REQUEST FOR INFORMATION

PROJECT	:	CADANGAN PEMBINAAN BALAI BOMBA DAN PENYELAMAT BEAUFORT SABAH			
ISSUED TO	:	KIA	ISSUED DATE	:	29.12.2020
ATTENTION	:	ENCIK NOOR IZWAN RAHIM	RF Info No.	:	RF Info/BOMBA/ 04
DESIGNATION	:	PRINCIPAL			
C.C	:

C/S.

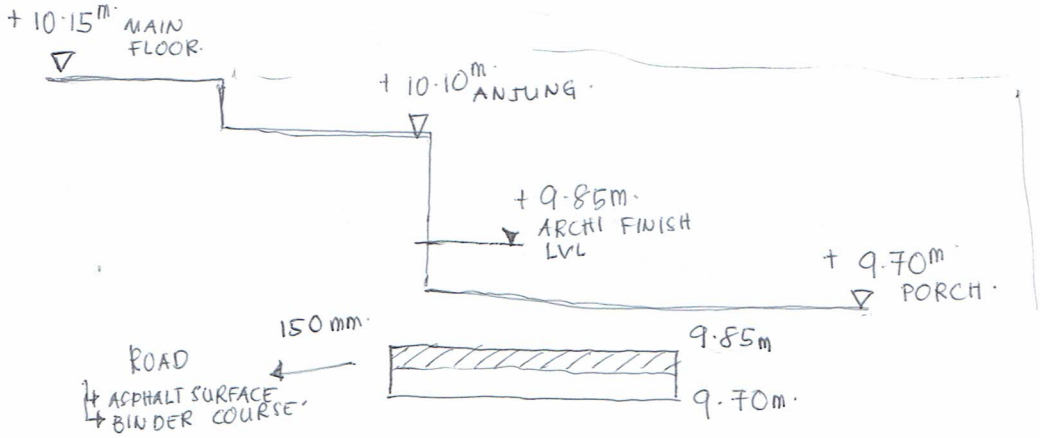
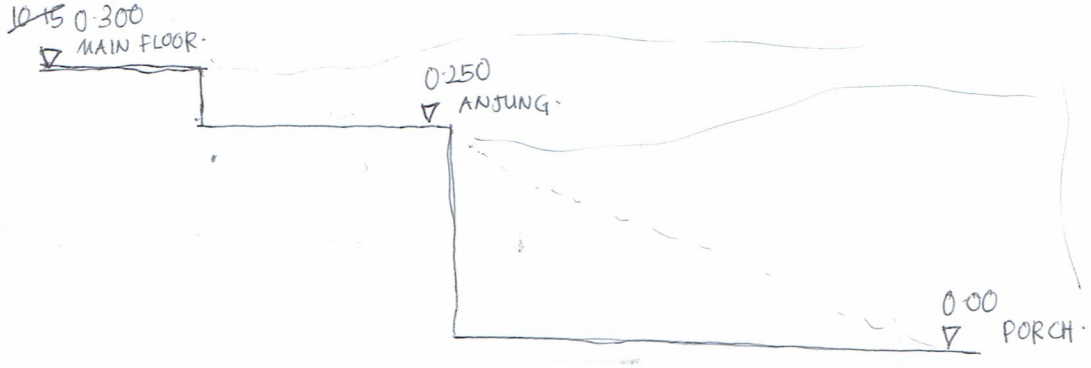
1. Confirmation of finish floor level.

-> ± 9.85M finish level for porch area.
C & S drawing.

-> ± 0.00M at Archt drawing.

+ 10.15m MAIN FLOOR
+ 10.10m ANJUNG
+ 9.85m ARCHI FINISH LVL
+ 9.70m PORCH
150 mm
ROAD
ASPHALT SURFACE
BINDER COURSE
9.85m
9.70m

10.15 0.300 MAIN FLOOR
0.250 ANJUNG
0.00 PORCH
